Re: SCE's Comments on the Draft Supplemental Environmental Impact Report (SEIR) for the Devers-Palo Verde No. 2 Transmission Line Project – Colorado River Substation Expansion

Exhibit 1: SCE Comments & Suggested Revisions

Exhibit 2: CRS; Southern Alternative and Right-of-Way Loop-In Towers

COLORADO RIVER SUBSTATION SOUTHERN ALTERNATIVE AND RIGHT OF WAY CORRIDOR FOR LOOP-IN TOWERS

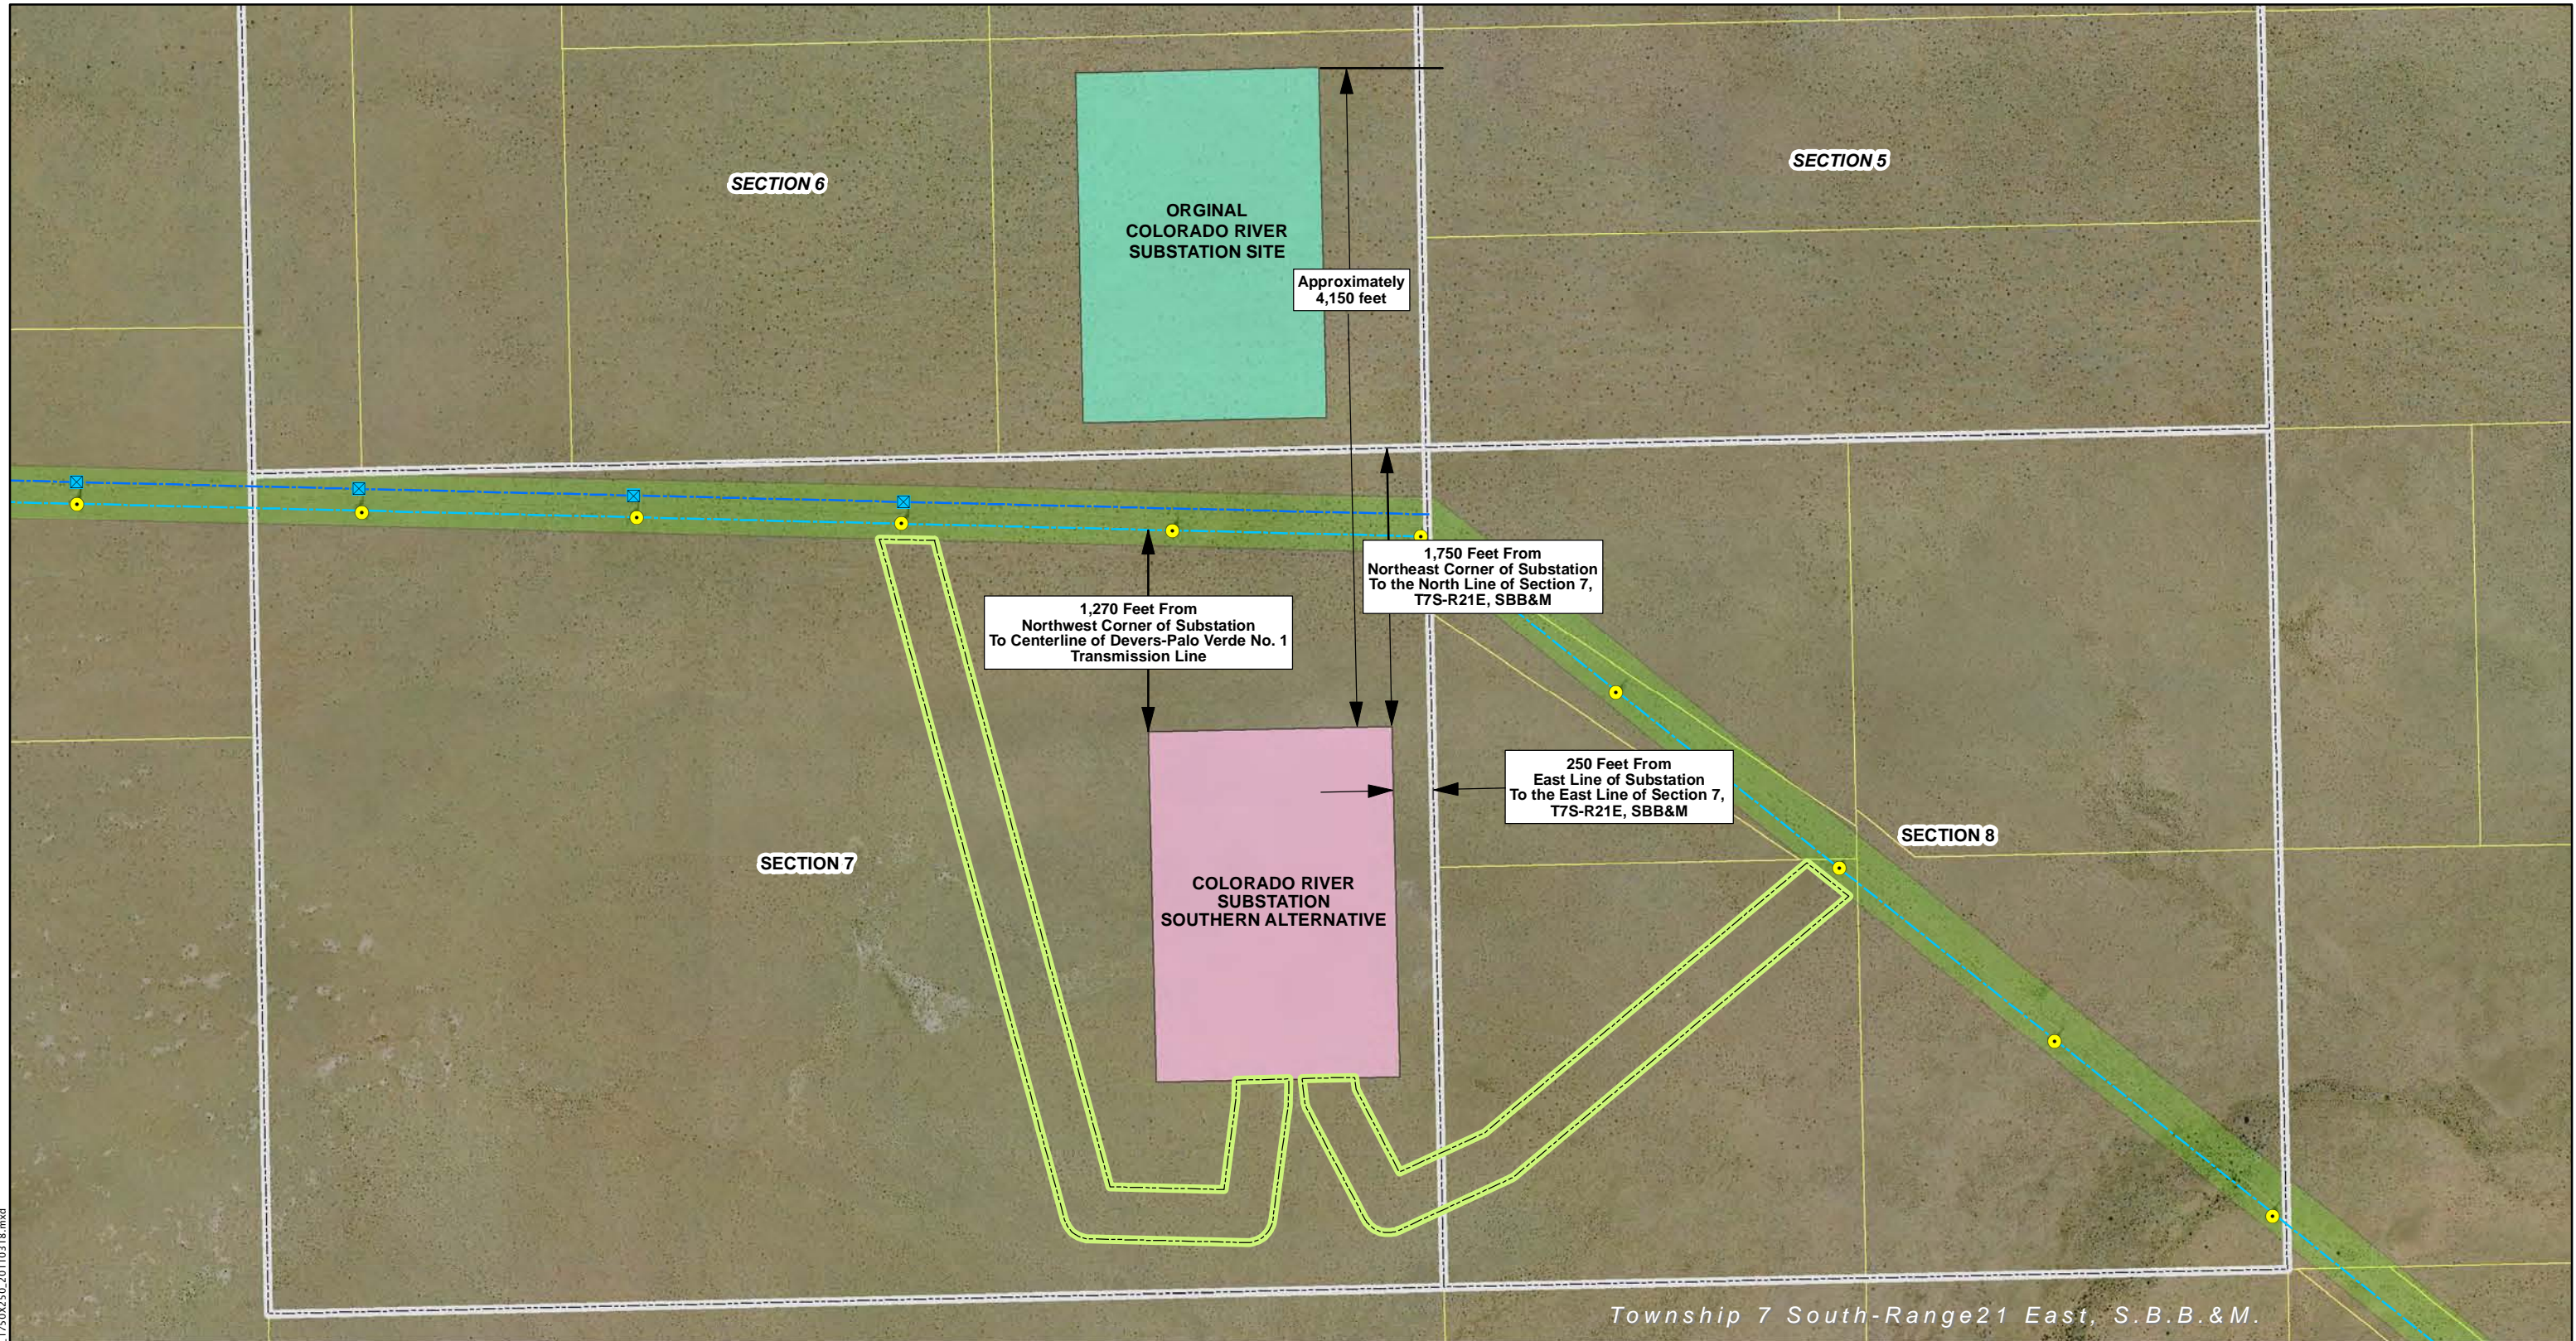
As shown in SCE's preliminary engineering concepts for the Southern Alternative (*see* Exhibit 2), the Southern Alternative site would accommodate CRS and all of its ancillary components, each of which would fall within the area already analyzed in the Draft SEIR. In fact, the Draft SEIR acknowledges that all of the ancillary components for development at any of the alternative sites have been incorporated into the environmental analysis. Given that all of the mitigation measures in the Draft SEIR would similarly apply to these components, the analysis correctly concludes that no additional significant impacts other than those described in the Draft SEIR would result at any of the alternative sites.

same substation layout already completed for the proposed CRS location could also be used at the Southern Alternative location, so long as the DPV1 and DPV2 transmission lines could enter and exit south of the site. (See section IV below and Exhibit 2.)⁵ In contrast, the other avoidance alternatives (including AA1) are depicted as parallel to the existing DPV1/DPV2 corridor, meaning that within the substation footprint itself, transmission line and bus positions would likely have to be re-sited in a manner different from the existing CRS design. In addition, the avoidance alternative sites are located immediately adjacent to the corridor housing the existing DPV1 lines and the Buck-Julian Hinds 220kV line owned and operated by Florida Light & Power (FPL). In order to comply with established electrical clearance requirements, additional engineering work would likely be needed to orient the multiple new transmission line connections into CRS in a manner which would not create interference among the existing and new lines. (See *generally*, CPUC General Order 95, § III, Table 2: Basic Minimum Allowable Clearance of Wires from Other Wires at Crossings, in Midspans and at Supports.) In particular, if the Buck-Julian Hinds 220kV line could not be lowered (or if FPL were to refuse to move it) in order to make room for the new 500 kV lines to be strung above the 220 kV line, SCE could be forced to install taller transmission line towers or poles to raise the 500 kV lines when crossing the 220 kV line into the substation. Depending on their ultimate height, such higher towers or poles could also trigger Federal Aviation Administration issues which could further delay implementation of CRS.

support of engineering, similar to what was performed at the current location. SCE expects to have access for this work within the next several weeks. In contrast, it is expected to take many months to obtain the necessary access to the private parcels to perform the same exploratory work. In fact, SCE already has made substantial progress in engineering the Southern Alternative in accordance with the Draft SEIR's depictions.⁶ For example, consistent with the Draft SEIR's statement that the substation should be shifted approximately 4,000 feet south of the proposed CRS site and approximately 1,300 feet from the existing DPV1 line, SCE has sited the Southern Alternative's northern footprint approximately 4,150 feet south of the proposed CRS site's northern boundary and approximately 1,270 feet south of DPV1. (See Draft SEIR, at p. Ap. 1-26; Exhibit 2.) As shown on Exhibit 2, the CRS facility fits well at that location.

Similarly, the Draft SEIR acknowledges that the DPV1/DPV2 transmission lines and BSPP/GSEP gen-tie lines would cross through BLM land within the sand transport corridor between the Southern Alternative site and the existing DPV1/DPV2 transmission corridor. (Draft SEIR, at p. C-11.) In order to provide the easiest means of gen-tie access from north (BSPP and GESP will be developed northeast and northwest, respectively, of the proposed CRS site), SCE already has designed the DPV1 and DPV2 transmission lines to enter into the substation from the south instead of the north. (See Exhibit 2.) This orientation was easiest to accomplish because it replicates the transmission line entry and internal substation layout that were previously designed for the proposed CRS site. As discussed further below, although this routing may result in slightly longer transmission lines with a few additional towers, the additional ground disturbance would be minor. In fact, to minimize ground disturbance impacts associated with tower foundations, SCE has designed the line route to be as perpendicular to the sand transport corridor as reasonably feasible. (See Exhibit 2.) This routing also alleviates electrical line interference issues by leaving a broad avenue for the gen-tie lines to directly connect into the Southern Alternative straight in from the north.

In addition, as discussed in the Draft SEIR, additional work to widen and extend the access road leading from Wiley Well Road to any CRS site would be required. (Draft SEIR, pp. D-51 – D-54.) To reduce the northwest-southeast distance of this additional access road (and thereby reduce impacts to the modeled sand corridor) as much as possible, SCE is already evaluating a number of different access road routes leading to the Southern Alternative, including routes parallel to the DPV1 and CRS-Devers transmission line routes depicted in Exhibit 2.

Similarly, SCE already has begun designing the routes for the electric distribution lines for substation light and power and SCE system telecommunication lines into and out of the Southern Alternative location. Because the Southern Alternative would be south of the proposed CRS site, the distribution lines for this alternative likely will be routed in generally the same north-south route already anticipated for the proposed CRS site, with a simple extension farther south.⁷
